RE: SITE PLAN – ADMINISTRATIVE DEVELOPMENT FACILITATION TEAM TRACT 52-A, UNIT 2 TRACTS ALLOTTED FROM TOWN OF ATRISCO GRANT PR-2018-001681 SUNSET GARDENS

Development Facilitation Team (DFT) – Review Comments

Project No: PR-2018-001681 Date: 03/06/2024 Agenda Item: #1 Zone Atlas Page: MX-L

Application For: SI-2024-00271 – SITE PLAN DFT

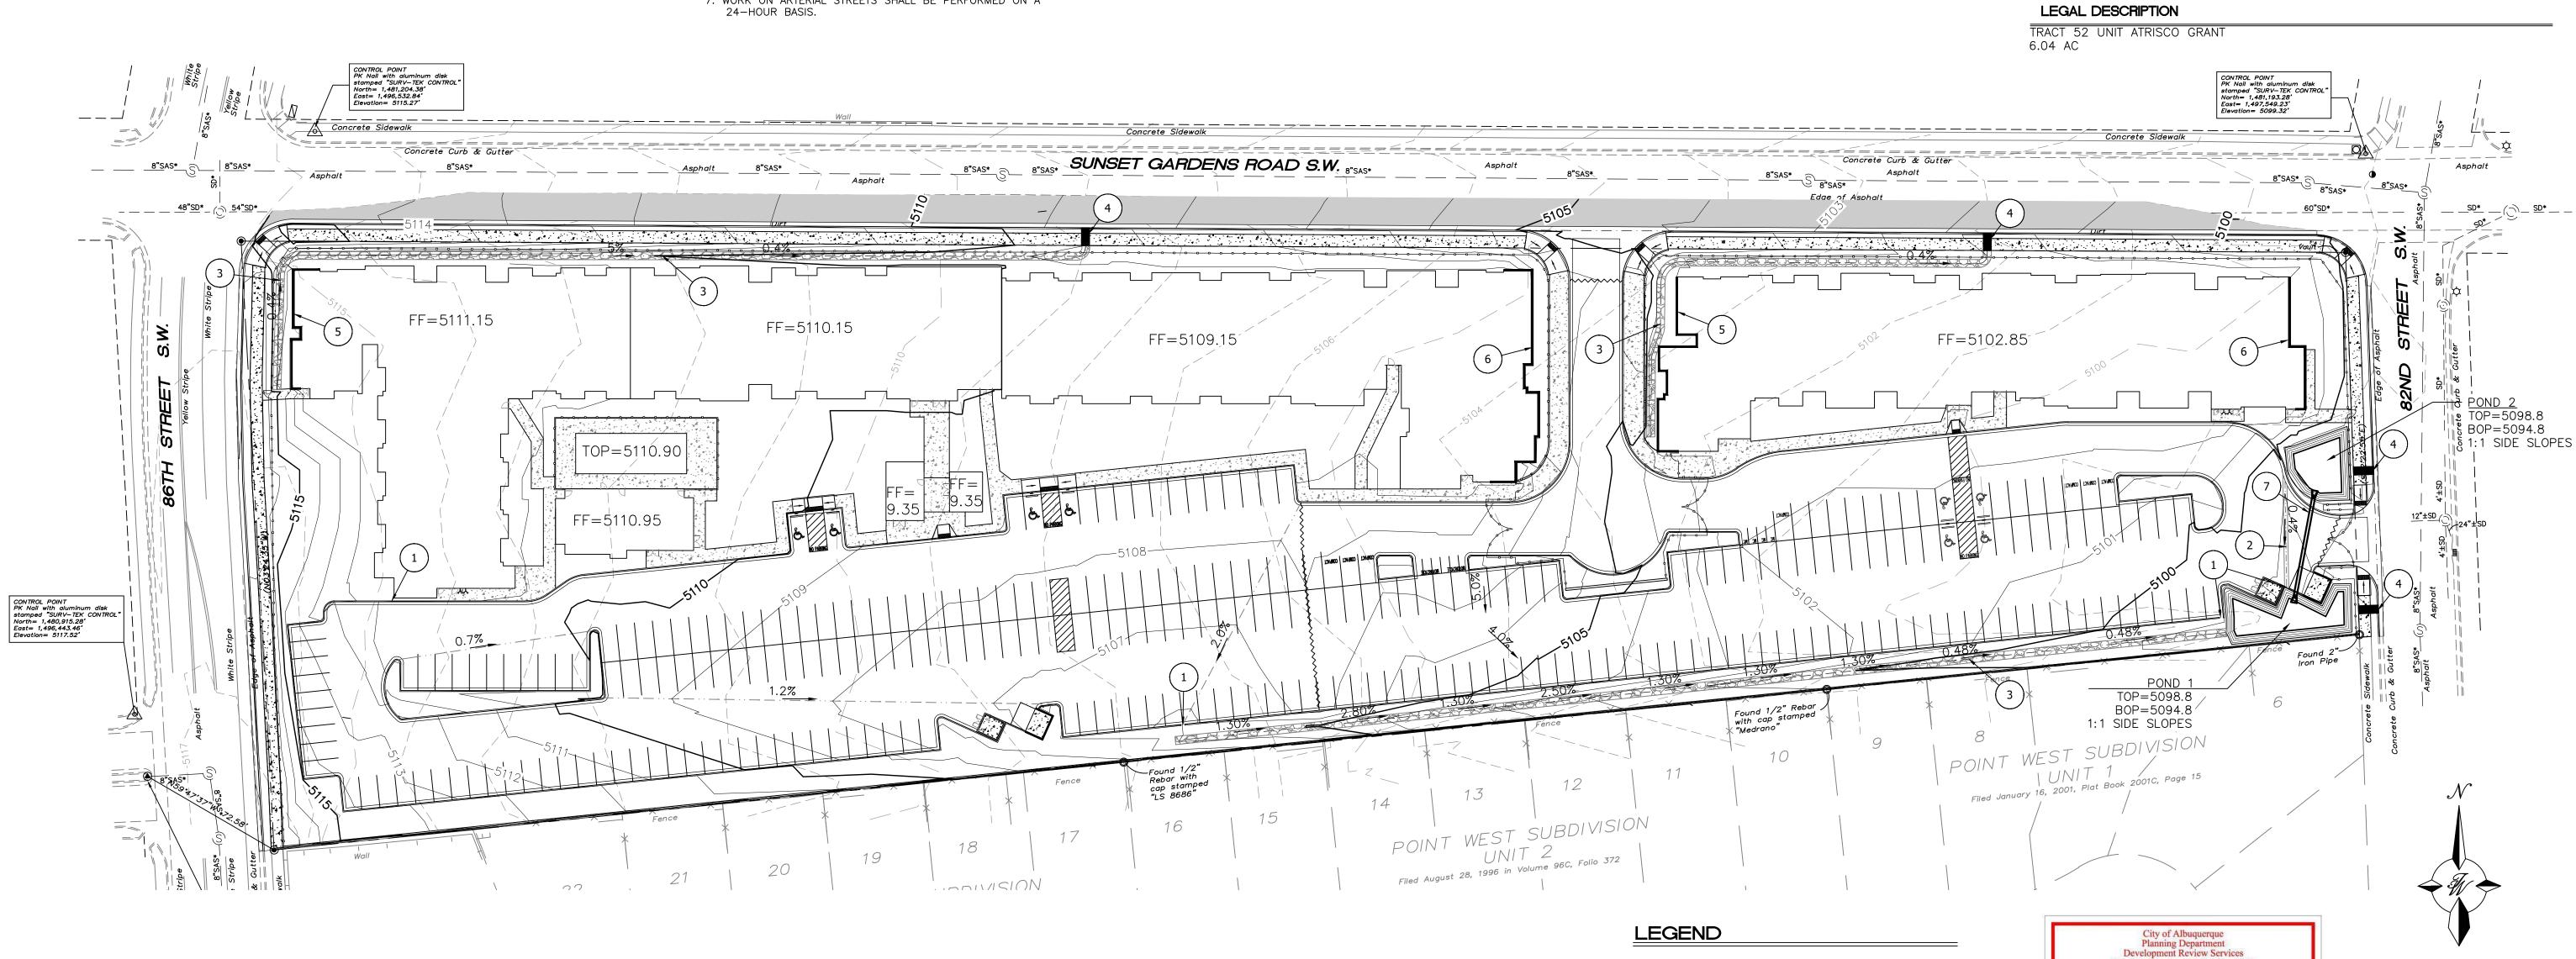
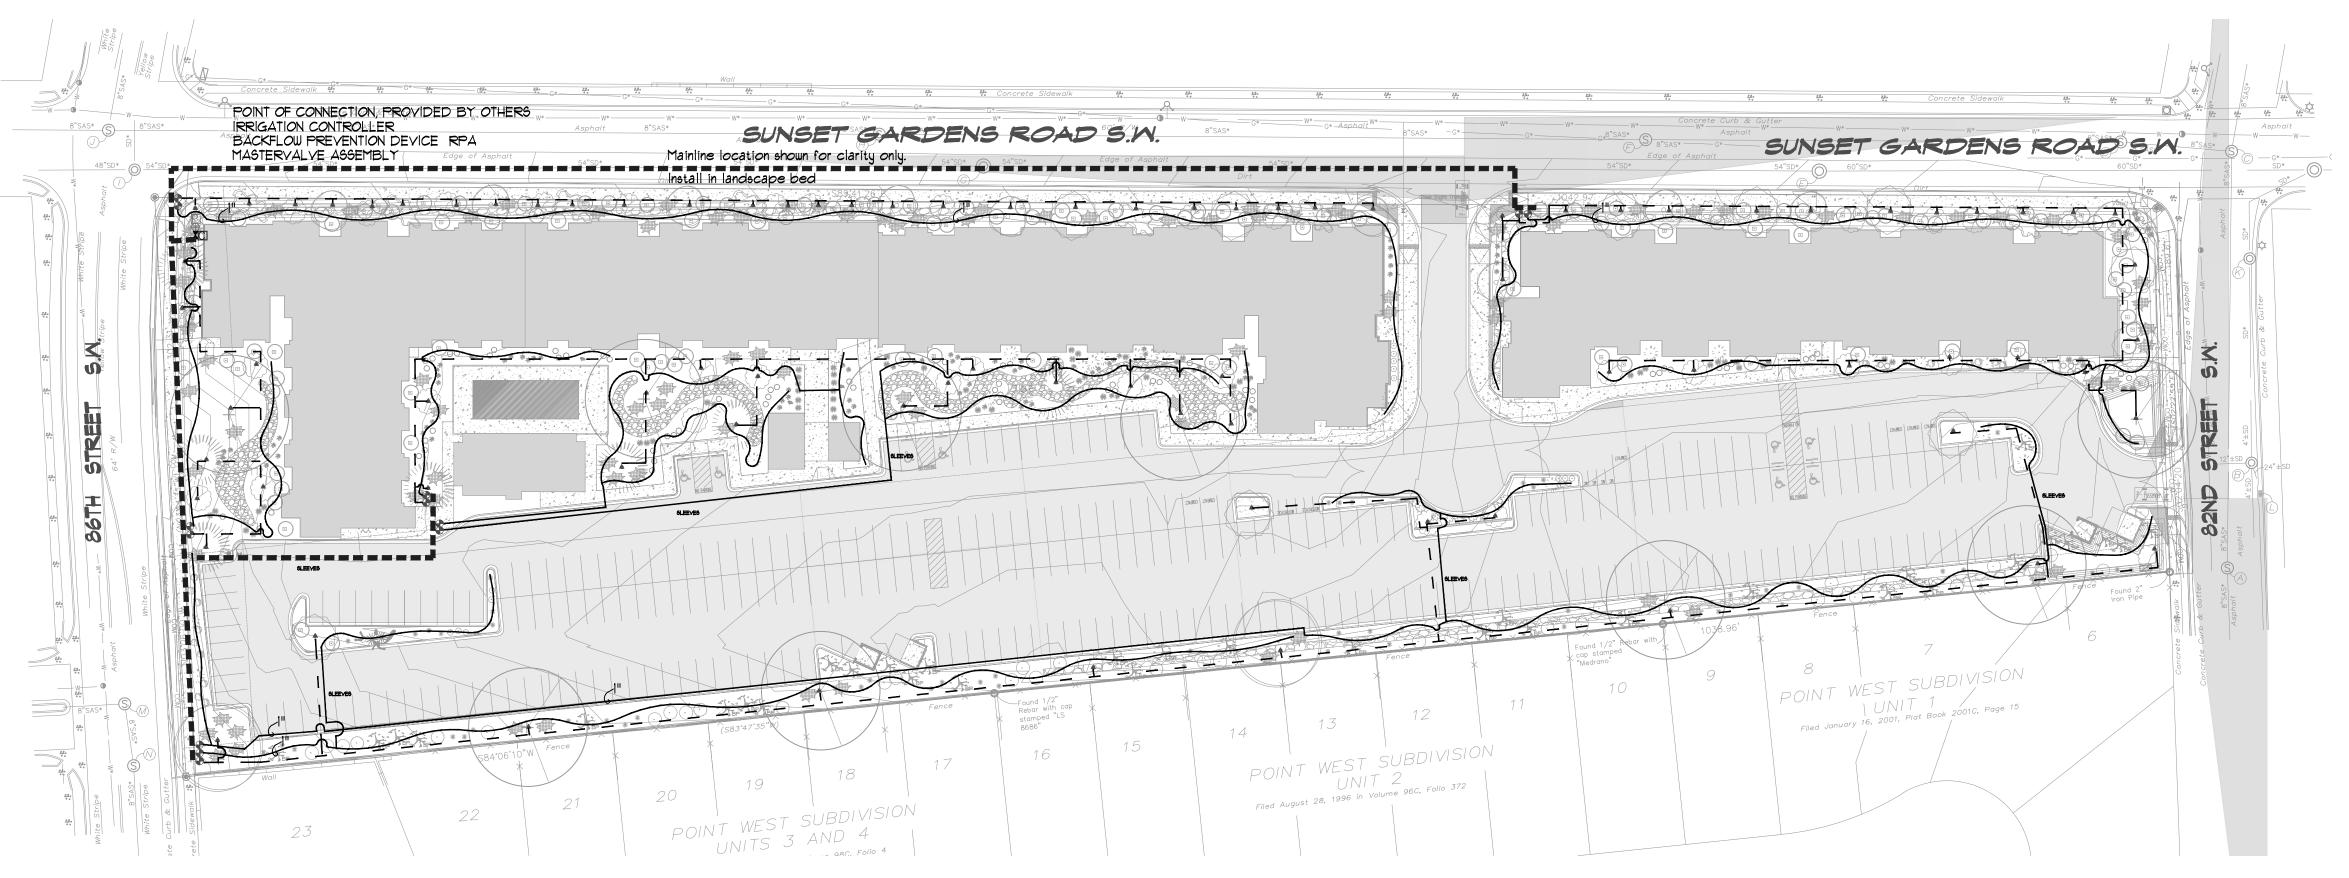
3. Provide landscaping Edge Buffer landscaping as per 14-16-5-6(E)(2)(a) zone to the south is R-1B in an area of consistency.

4. Provide parking lot landscaping as per 14-16-5-6(F)(1)(i)(2) and parking lot trees as per 5-6(F)(2)

7. Indicate how many units are on the ground and second level and provide tree count accordingly as required by 14-16-4-3(B)(c)

Please confirm compliance with this code. Minimum required landscape area does not match the number on the Site Plan.

Please make adjustments to add buffer along the south property edge in order to meet this code.

Please provide calculations and note on the plans either through measurements or standard detail for how street tree requirements are being met per IDO 14-16-5-6(D).

RESPONSE: See updated landscape plan LS-101.

RESPONSE: See updated Landscape Plan LS-101.

RESPONSE: Refer updated landscape sheet LS-101 for landscape calculations.

RESPONSE: Confirmed see updated landscape sheet LS-101.

RESPONSE: see updated landscape plan sheet LS-101.

RESPONSE: Refer sheet LS-101 for calculations.

RONALD R. BOHANNAN www.tierrawestllc.com SHEET # C3.0 JOB #

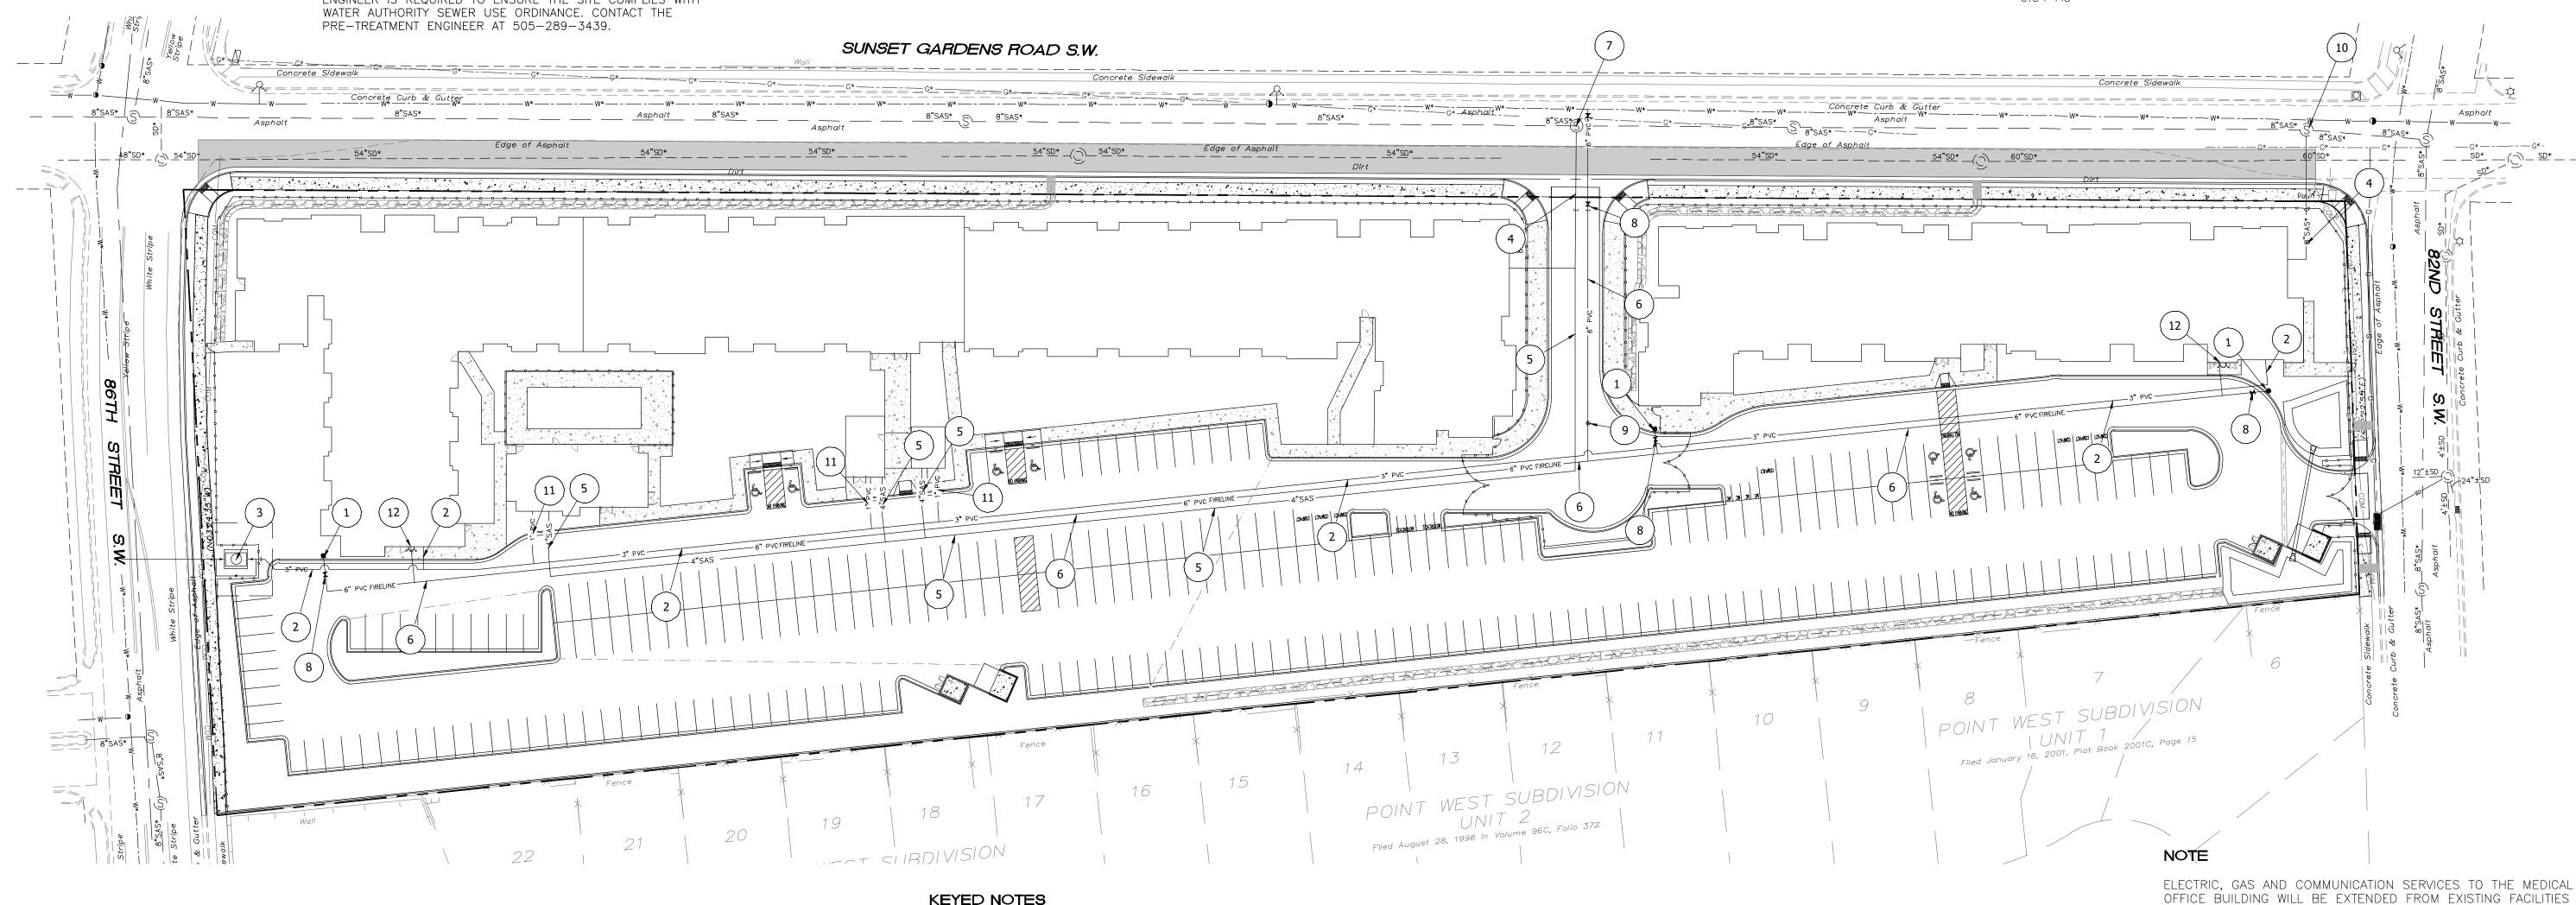
2. Please label the fire hydrants on-site as private and to be painted safety orange.

Please confirm compliance with this code per master utility plan, based on the proposed fire hydrant, valve vault, manhole etc.

Please confirm compliance with this code per proposed water and sewer lines shown on the utility plan.

RESPONSE: Refer keynote #1 on the master utility plan sheet C3.0.

RESPONSE: see utility plan notes.

BUILDING 2 NORTH ELEVATION

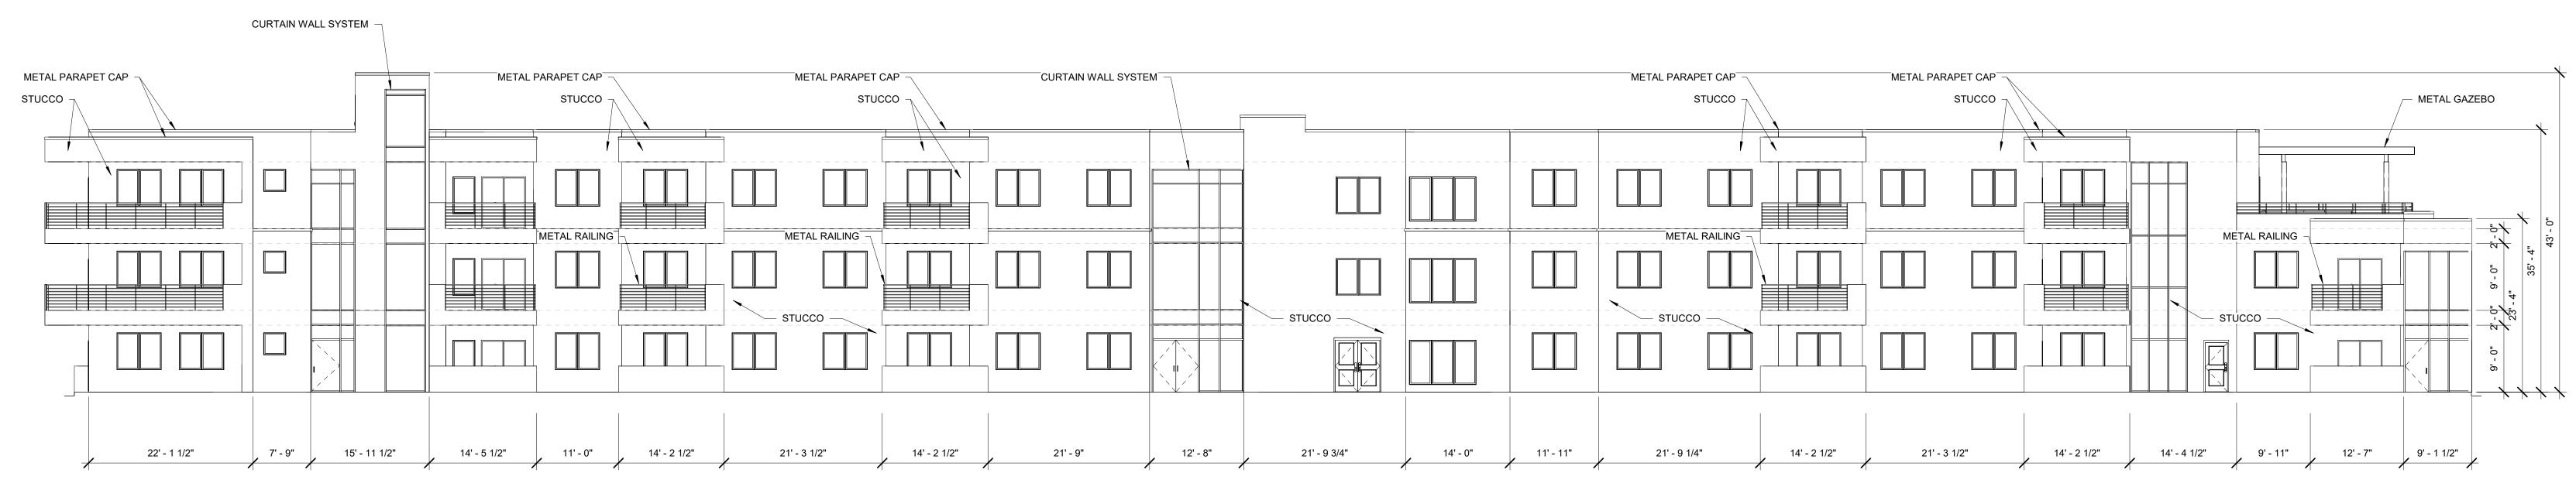
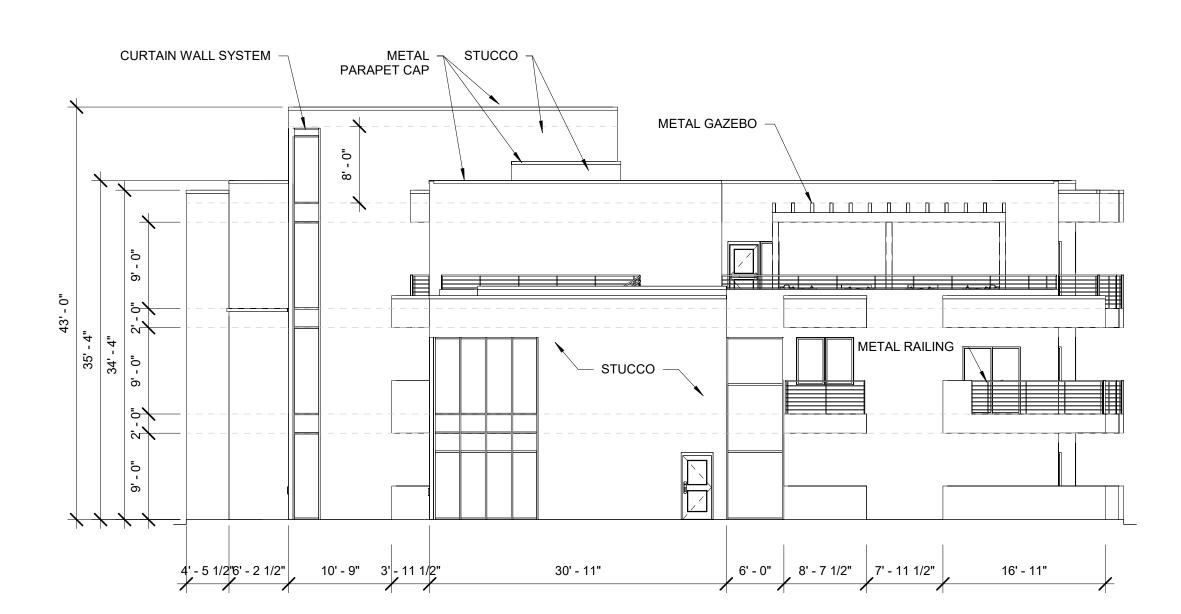
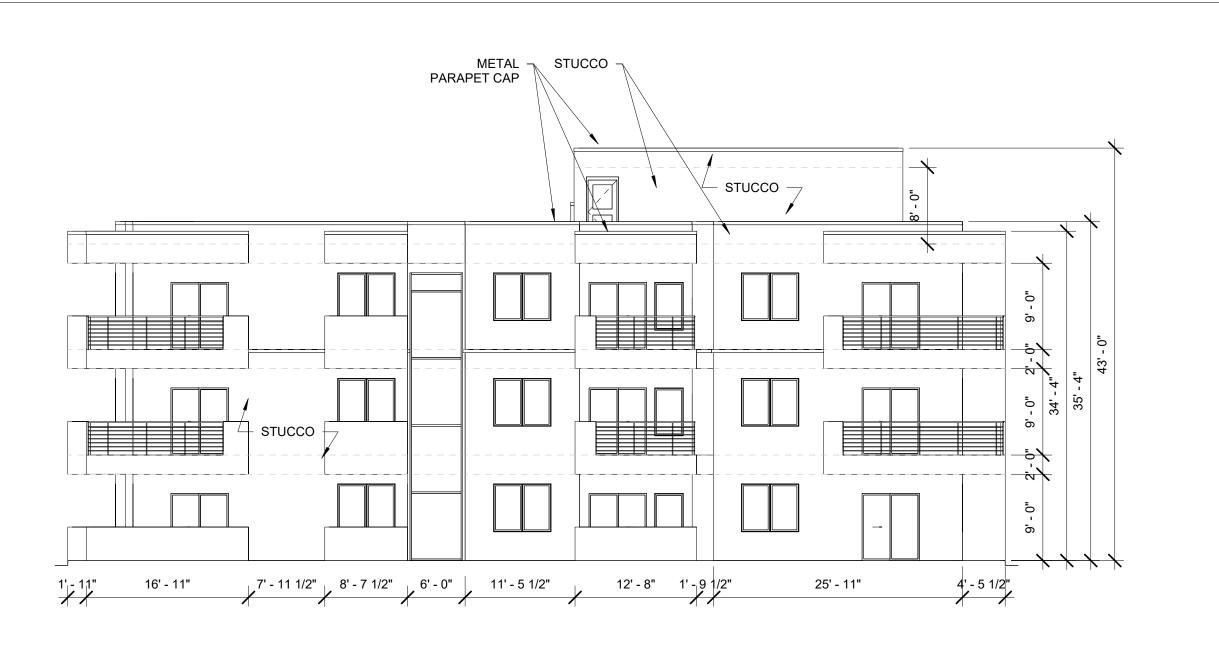
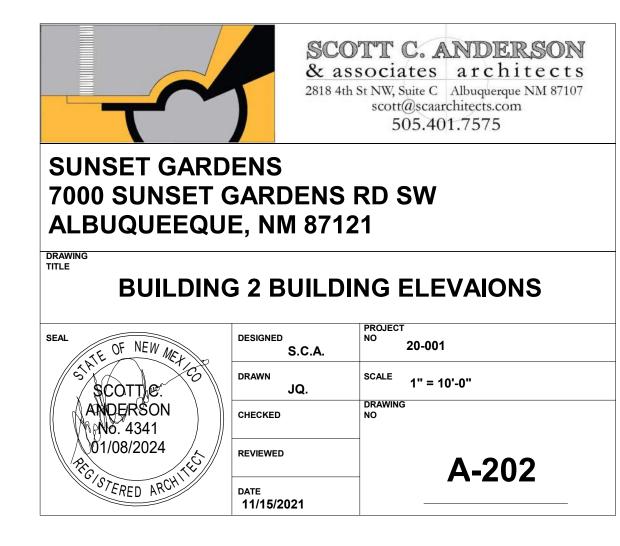
-Maximum Building Height: 38 ft. / proposed Building Height: 38'-4" — Please address RESPONSE: Revised building heights to 38'-0".

4. Windows facing west shall use heat mitigation features. Please articulate how the project complies with this code. Please consider renaming the side elevations to easter west elevation in order to clarify this item.

Please make proper changes to comply with this code. Provide vertical and horizontal dimension lines on the elevations.

RESPONSE: See updated Elevation sheets directions clarified.

RESPONSE: See updated Elevations and dimensions.
